# UNITED STATES PATENT AND TRADEMARK OFFICE

APPLICATION NO.	FILING DATE	FIRST NAMED INVENTOR	ATTORNEY DOCKET NO.	CONFIRMATION NO.
10/538,968	06/14/2005	Mensur Velicanin	BM-173PCT	7510
40570	7590	10/28/2009		
FRIEDRICH KUEFFNER 317 MADISON AVENUE, SUITE 910 NEW YORK, NY 10017			EXAMINER FULTON, KRISTINA ROSE	
			ART UNIT 3673	PAPER NUMBER
			MAIL DATE 10/28/2009	DELIVERY MODE PAPER

### Office Action Summary

**Fig.11**

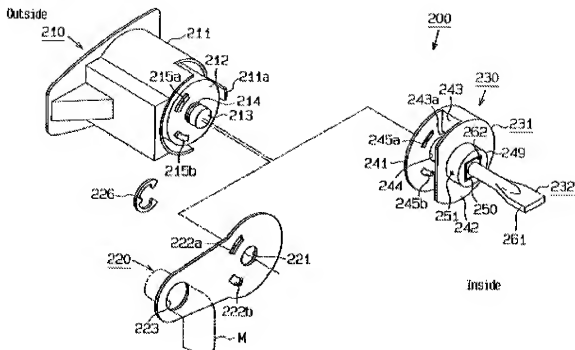
6. Regarding claim 1, Katagiri shows an actuating device for a lock in a door or hatch of a motor vehicle (column 1, line 8), with a lock cylinder (200), which has a lock (column 9, lines 57-58) located a certain axial distance away and a one-piece shaft (232) extending between the lock cylinder and the lock; which shaft transmits a force to the lock when the lock cylinder is rotated; the shaft is flexible in an axial direction of the shaft to compensate for a radial offset between the axis of the lock cylinder and the lock (column 12, lines 15-25) and wherein a driver (261) for actuating the lock and/or a connection (230) for the lock cylinder is formed integrally on the shaft. See the Katagiri device below.

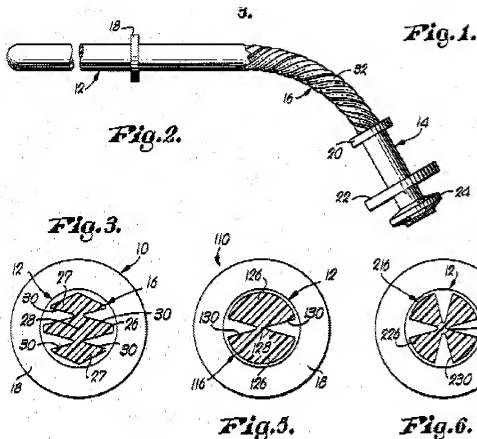
7. Although Katagiri shows applicant's basic inventive concept of an actuation device for a lock in a motor vehicle, Katagiri fails to show a shaft which submits a torque having the claimed notches, but Brahler shows this to be well known in the art. Brahler shows a flexible drive shaft (10), usable in any application (column 4, lines 40-48) for transmitting torque (column 4, line 31) wherein the one-piece shaft is made of flexible material (see claim 1) and has a family of notches (30) extending transversely to the axis of the shaft; the notches are recessed in pairs (see figure 3) into the shaft from diametrically opposing sides, the notches each having two flanks (each side of the notch); wherein when the shaft is stretched out straight, the two flanks of the notches are "essentially" parallel to each other and extend radially with respect to the axis of the

shaft; wherein the notch pairs leave a web (28) in the shaft between the flanks the web is located on the axis of the shaft and extends essentially across the entire diameter of the shaft; the web produces flex points(see bending at 32 in figure 2), at which, when bending load is exerted on the shaft, the two flanks of the notch pairs can swing toward or away from each other (the flanks can bend toward or away from each other depending on the bending of the shaft); wherein intermediate axial pieces (26, 27), extending in the axial direction of the shaft and with the full cross section of the shaft , remain between successive pairs of diametrically opposing notches. It would have been obvious to one of ordinary skill in the art to replace the shaft portion of Katagiri using the flexible shaft of Brahler to provide enhanced flexibility. Replacing one flexible shaft with another flexible shaft is considered to be within the level of ordinary skill in the art. See the Brahler device below.
